UNITED STATES PATENT AND TRADEMARK OFFICE

APPLICATION NO.	FILING DATE	FIRST NAMED INVENTOR	ATTORNEY DOCKET NO.	CONFIRMATION NO.
10/644,729	08/21/2003	Takefumi Suzuki	000560-00123	6194
27557	7590	09/17/2004	EXAMINER	
BLANK ROME LLP 600 NEW HAMPSHIRE AVENUE, N.W. WASHINGTON, DC 20037			SHAKERI, HADI	
			ART UNIT	PAPER NUMBER
			3723

Office Action Summary

DETAILED ACTION

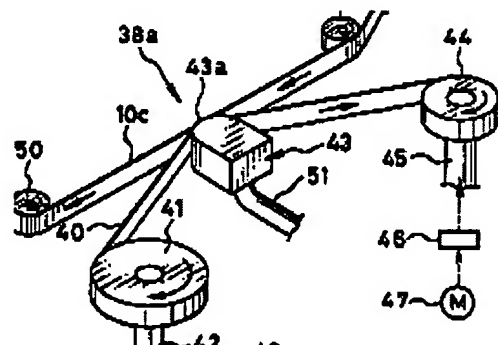
Applicant may wish to rewrite the claims into Jepson type claims, since the device for correction of metal rings' peripheral length (i.e., items 2-4 in Fig. 1, including movable driven roller) is old as admitted by the applicant and since the improvement to the prior art device is the addition of item (5).
